Notice of Allowability	Application No.	Applicant(s)	
	10/671,273	YEN, CHIN-HSIEN	
	Examiner	Art Unit	
	Terry L. Englund	2816

EXAMINER'S AMENDMENT

FIG. 1A (PRIOR ART)

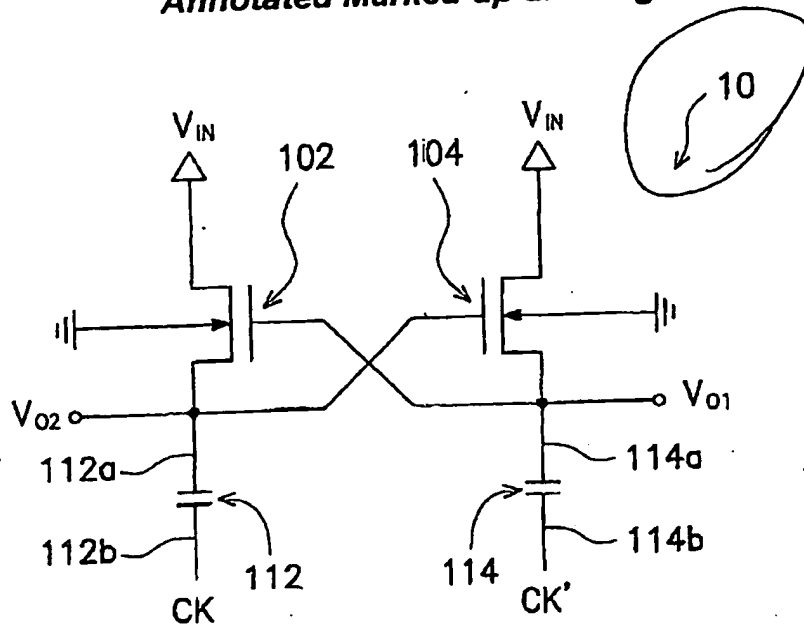
Annotated Marked-up drawing
